**Appl. No.** : **09/764,680**  
**Filed** : **January 18, 2001**

### **REMARKS**

Appl. No. 09/764,680  
Amendment Dated Nov. 29, 2004  
Reply to Office Action of August 27, 2004  
Annotated Sheet Showing Change

FIG. 1 (PRIOR ART) added

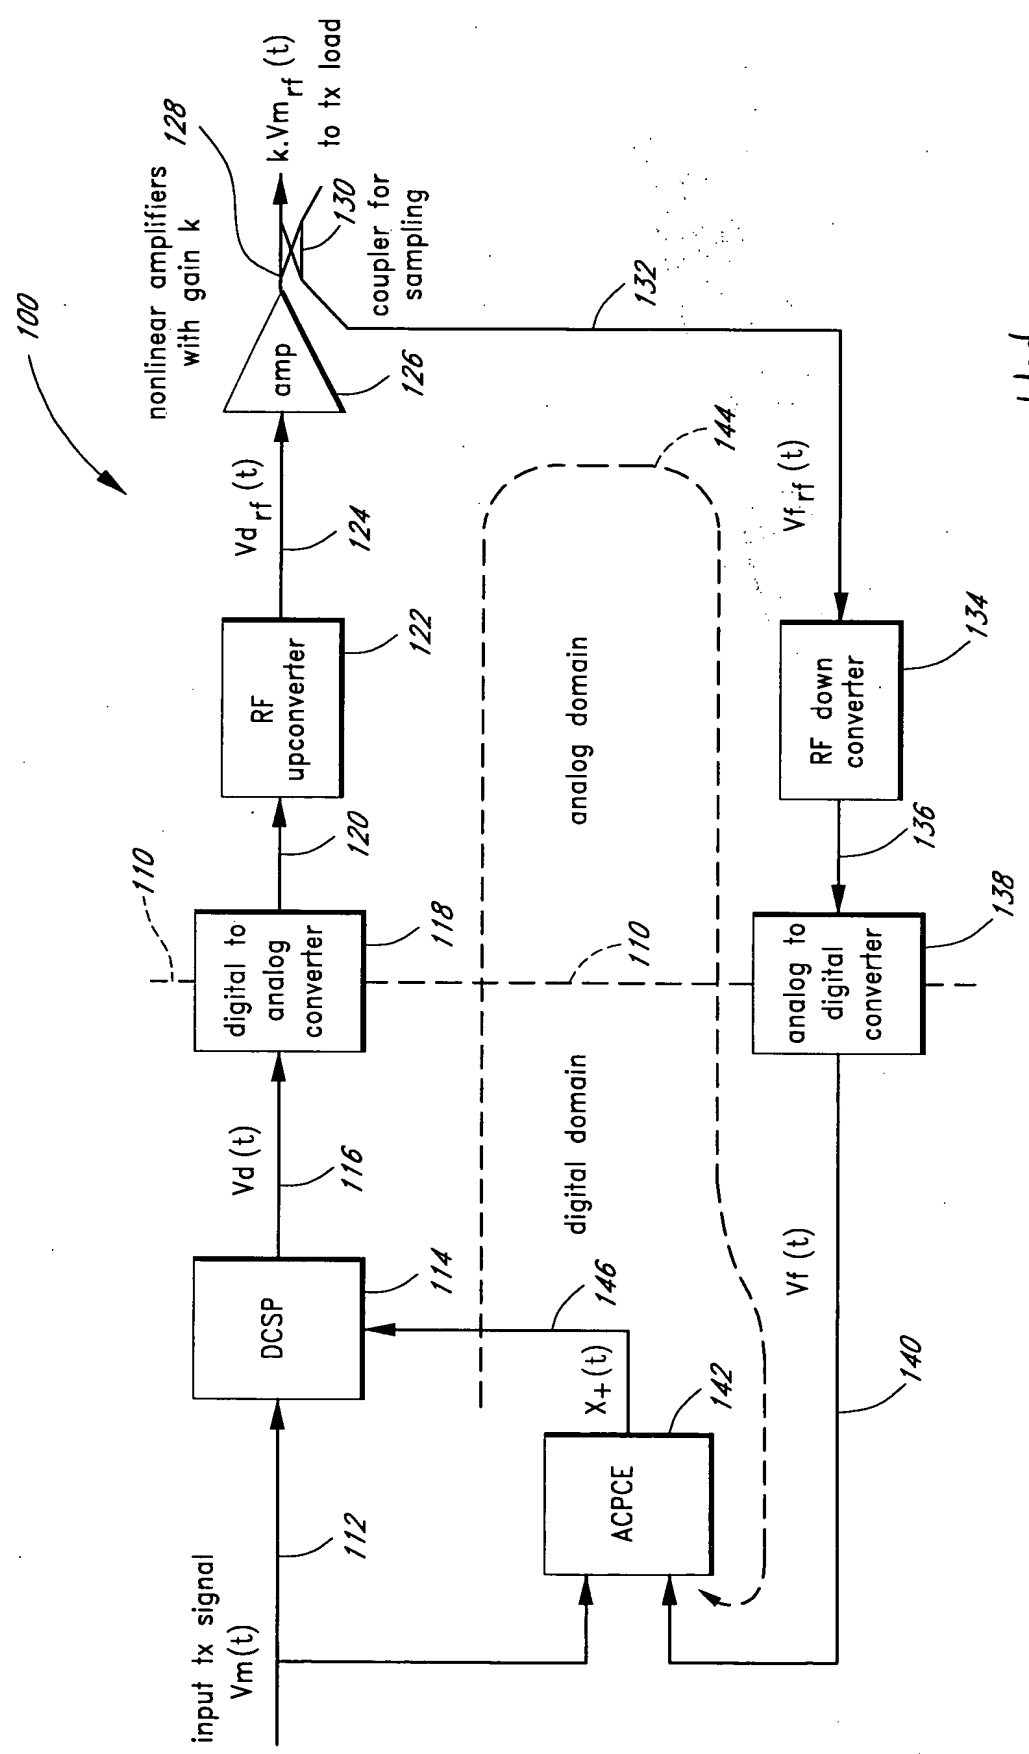
In the Office Action of August 27, 2004, the Examiner states that he did not receive legible copies of the references provided by Applicants in a March 29, 2001 Information Disclosure Statement; objects to Figure 1; objects to Claims 1, 6, 20, 25, and 26 for informalities; rejects Claims 7-19, 22, 23, and 26-31 under 35 U.S.C. § 112, first paragraph; rejects Claims 1-6 under 35 U.S.C. § 112, second paragraph; rejects Claim 1 under 35 U.S.C. § 103(a) as being obvious over U.S. Patent No. 4,291,277 to Davis, et al., ("Davis") in view of U.S. Patent No. 4,810,977 to Flugstad, et al.; rejects Claims 4 and 21 under 35 U.S.C. § 103(a) as being obvious over Davis in view of Flugstad, further in view of U.S. Patent No. 5,699,383 to Ichiyoshi ("Ichiyoshi"); and rejects Claims 7-12, 19, 20, 24-26, and 32 under 35 U.S.C. § 103(a) as being obvious over Davis in view of Ichiyoshi. Applicants request reconsideration of the rejections in view of the foregoing amendments and the following comments.

Applicants are submitting herewith a corrected drawing for Figure 1. The corrected drawing include the legend "Prior Art" on Figure 1 as required by the Examiner. Accordingly, Applicants request the Examiner to withdraw the objection to the drawings.

The attached sheet of drawings includes changes to Figure 1. This sheet replaces the original sheet for Figure 1. In Figure 1, the legend "Prior Art" has been added.
